**Nomination Form**
**Anadromous Waters Catalog**

Name of Waterway: Powerline Creek

**Powerline Creek Route Correction**

Figure 1. Powerline Creek Route Correction Map

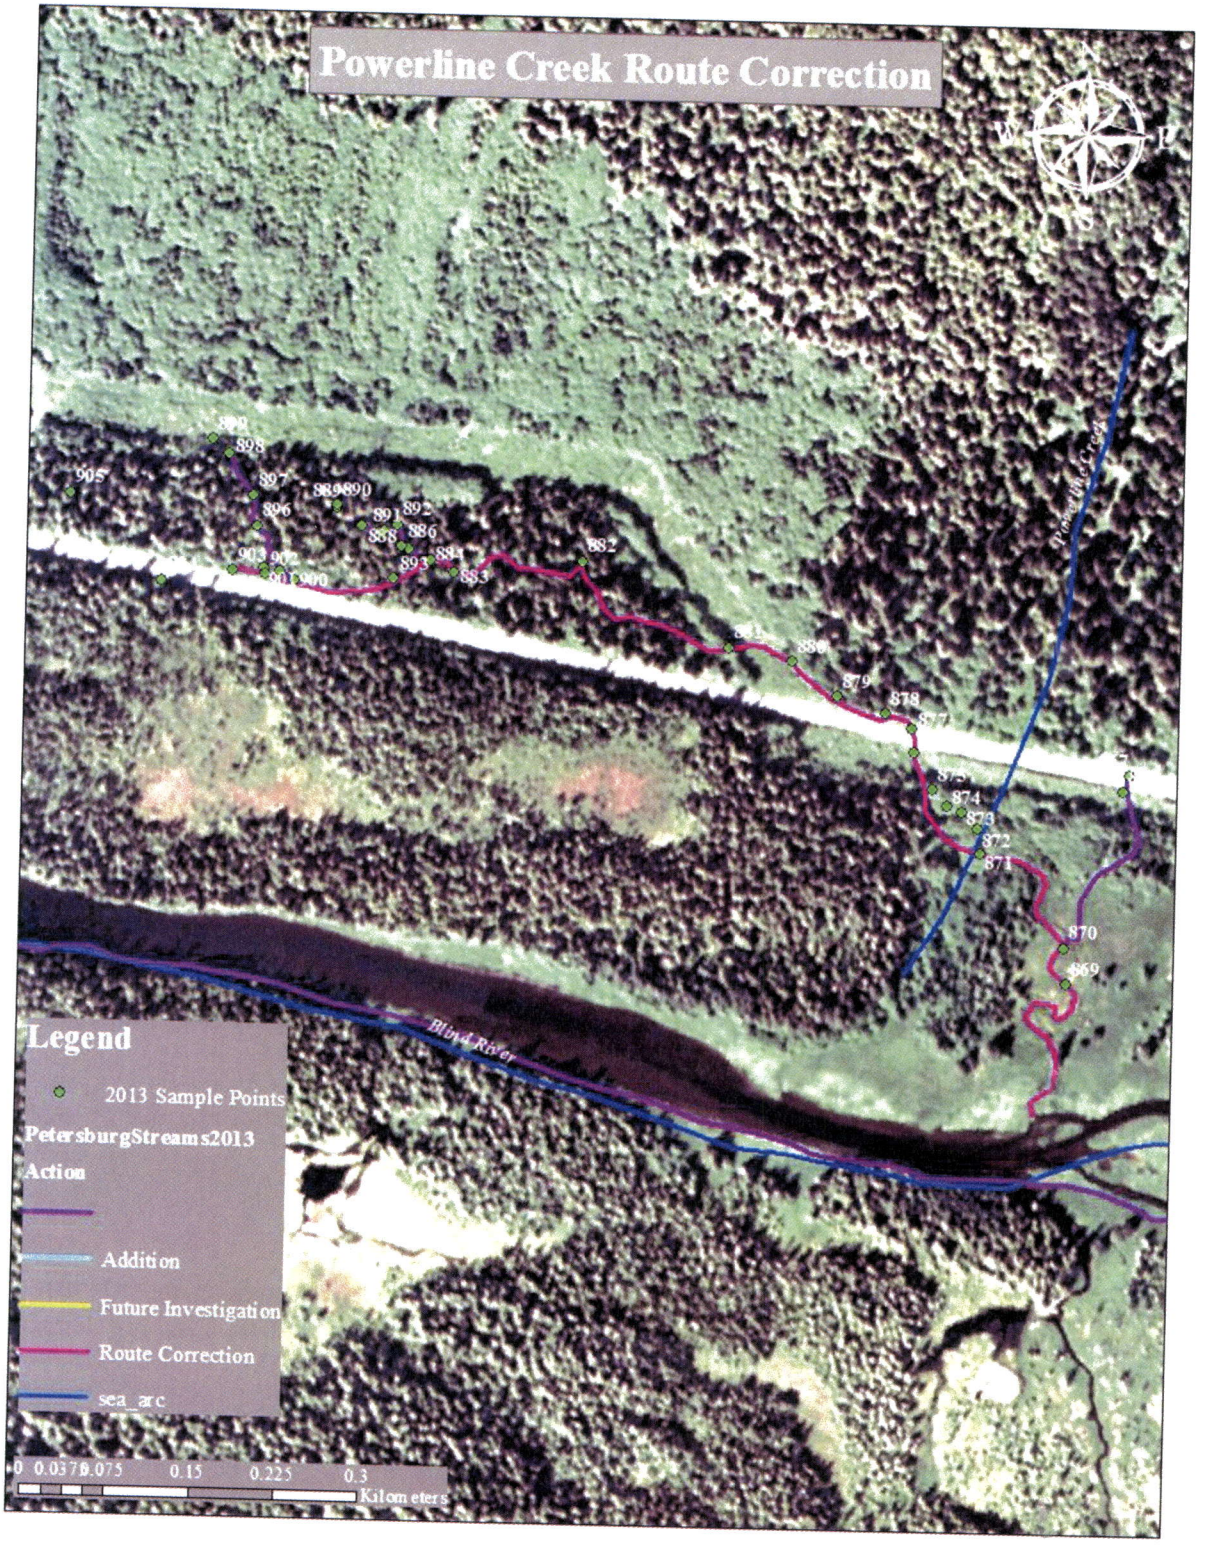
*Findings*: This stream's route differs severely from that illustrated in the AWC.

*Recommendations*: Update this stream's course to reflect its field-verified route and sinuosity in the AWC.

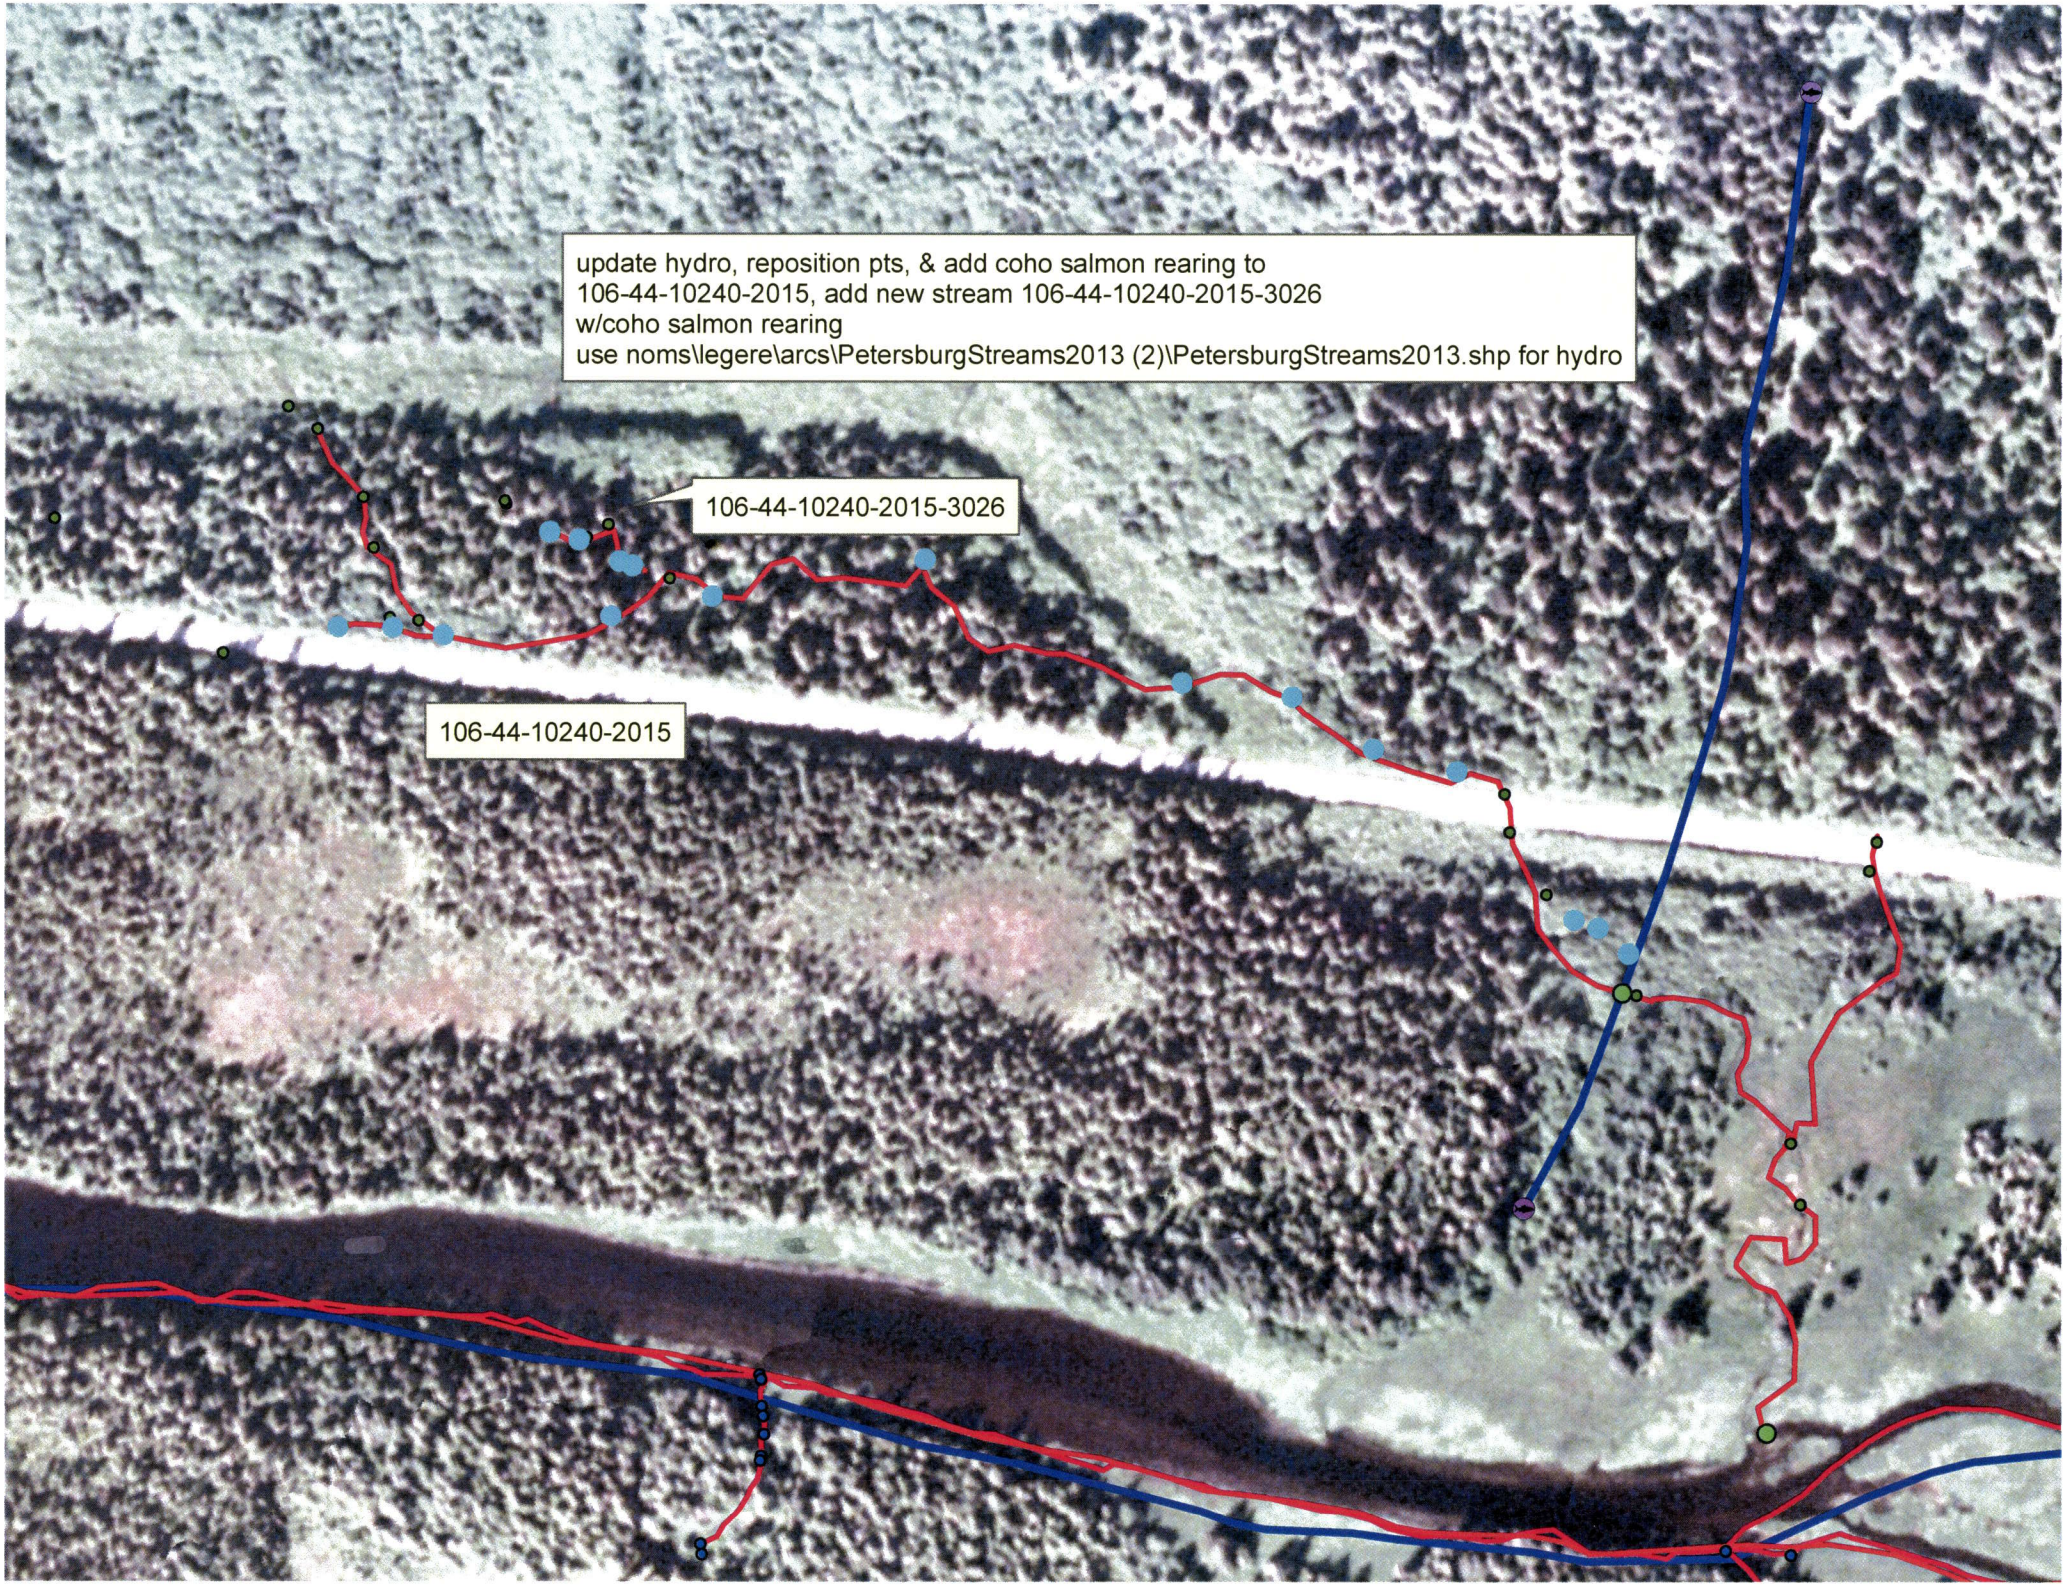
update hydro, reposition pts, & add coho salmon rearing to
106-44-10240-2015, add new stream 106-44-10240-2015-3026
w/coho salmon rearing
use noms\legere\arcs\PetersburgStreams2013 (2)\PetersburgStreams2013.shp for hydro
106-44-10240-2015-3026
106-44-10240-2015
